Subject: Docket No. 466, Frost Bridge to Campville 115-kV Project

Decision and Order Condition #4 – Independent Environmental Inspector Report

Please find enclosed the Biweekly Independent Environmental Inspector Report, Report #23, for the **October 13**th and **October 20**th, **2017**, inspection events for the construction of the Eversource Frost Bridge to Campville 115-kV Project.

Photo 7: 10/20/2017, Harwinton: Map 32, culvert replacement at W-F11/S-F10, southwest of Str87.

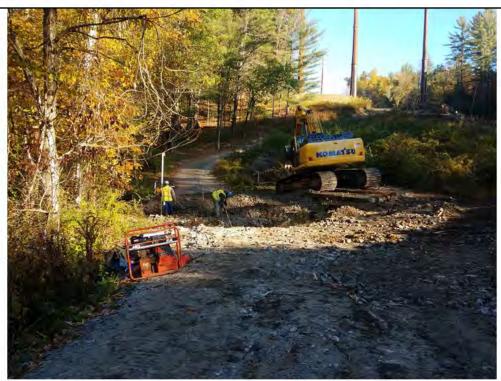
BluRoc was observed on site in the area of Str24 to Str46 continuing restoration activities (See Photo #5) and a crew of 3 was observed starting the culvert replacement at W-F11/S-F10 (Map 32, Harwinton), southwest of Str87 (See Photos #6 and #7).

Inland Wetland and Watercourse encroachment and mitigation (Continued from previous page)	Bi-Week	Restoration and upland stabilization of disturbed areas has begun site wide. The culvert replacement started on the day of this inspection. Markout and elevation surveying was in progress, and rough cuts with an excavator to designate the culvert extents was being done. E&S controls will be put in place where needed and the crew identified two temporary staging areas adjacent to the work area for the excavated soils/sediments.	N/A	In Progress
Spills and Material Storage	Interim-Week	None observed, none reported.	N/A	N/A
Spills and M	Bi-Week	None observed, none reported.	N/A	N/A
